**Arkwood, Inc., Superfund Site**  
**Comments on Revised Conceptual Site Model**

Item No.	Reference	Comments by EPA Dated July 18, 2014	PRP Response Dated: August 28, 2014
1.	Revised CSM General	<p>EPA has updated the Standard Default Exposure Factors used by the Superfund program:  <a href="http://www.epa.gov/oswer/riskassessment/pdf/superfund-hh-exposure/OSWER-Directive-9200-1-120-ExposureFactors.pdf">http://www.epa.gov/oswer/riskassessment/pdf/superfund-hh-exposure/OSWER-Directive-9200-1-120-ExposureFactors.pdf</a></p> <p>These Standard Default Exposure Parameters are used in the Regional Screening Level (RSL) calculator.  <a href="http://www.epa.gov/region6/6pd/rcra_c/pd-n/screen.htm">http://www.epa.gov/region6/6pd/rcra_c/pd-n/screen.htm</a></p> <p>The RSL calculator shows, as of May 2014, the updated non-cancer screening level for 2,3,7,8-TCDD toxicity equivalent quotient (TEQ) for an industrial worker is 730 part per trillion (ppt).</p>	McKesson acknowledges these recent changes in the RSL calculator showing a slightly higher compliance value of 730 ppt TEQ for industrial site PCDD/Fs.

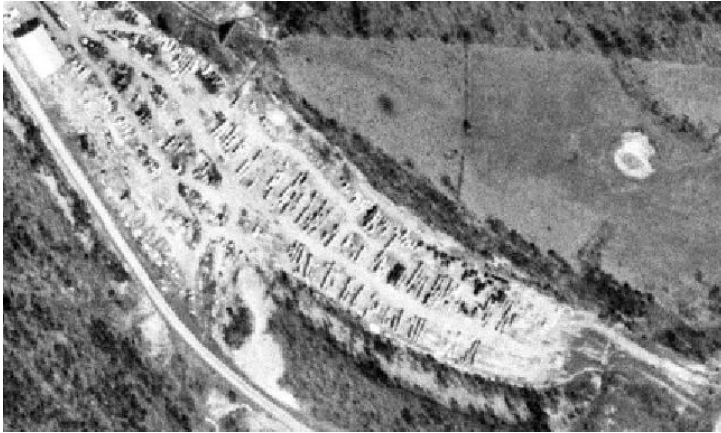
<p><u>homogeneous</u> within its borders (i.e., SUs will probably have similar results), no less than 7 SU-IS results are needed.</p> <p>b. ...and the DU is expected to be heterogeneous within its borders (i.e., SUs will probably have very different results), no fewer than 10 SU-IS results are needed.</p> <p>c. If the number of SUs in the DU is fewer than these limits, then all SUs should be sampled.</p> <p>2. If the average <u>DU concentration is expected to be far above or below</u> the action level/decision threshold...</p> <p>a. ...and the DU is expected to be <u>fairly homogeneous</u> within its borders (i.e., SUs will probably have similar results), no less than 5 SU-IS results are needed.</p> <p>b. ...and the DU is expected to be heterogeneous within its borders (i.e., SUs will probably have very different results), no fewer than 7 SU-IS results are needed.</p> <p>c. If the number of SUs in the DU is fewer than these limits, then all SUs should be sampled.</p> <p>ii. If the number of SU-ISs actually collected is less than these guidelines, the nonparametric Chebyshev UCL must be used since there is likely insufficient data for reliable results from parametric distribution tests.</p> <p>1. If the Chebyshev UCL exceeds the decision threshold:</p> <p>a. Either the DU must be considered to</p>

<p>exceed the threshold, or</p> <p>b. Additional SU-ISs can sampled to add to the data set so that the UCL might be calculated as less than the threshold.</p> <p>2. If the Chebyshev UCL does not exceed the decision threshold:</p> <p>a. Evaluate the actual between-SU variability for this DU <u>AND in neighboring or similar DUs</u> for indications that the sampling design was inadequate to capture the full range of variability.</p> <p>b. Determine the highest between-SU standard deviation (SD) among all similar DUs. Use this SD to recalculate Chebyshev UCLs for the DU.</p> <p>i. If the Chebyshev UCL exceeds the decision threshold, follow Line #1 directly above.</p> <p>ii. If the Chebyshev UCL calculated with the worst case SD does not exceed the decision threshold, no additional sampling is needed.</p> <p>d. Because the SU-ICS samples do not represent estimates of the DU mean, the variability between SU-ICSs can be expected to be higher than the variability between DU-ICSs, which will increase the distance between the calculated mean and the UCL.</p> <p>e. Again, because the SU-ICS samples are not estimates of the DU mean, the t-UCL cannot be used unless there are enough SU-ICSs to establish that the distribution of SU-ICS results is normally distributed. Therefore, a 95% Chebyshev (nonparametric) UCL must be used.</p>
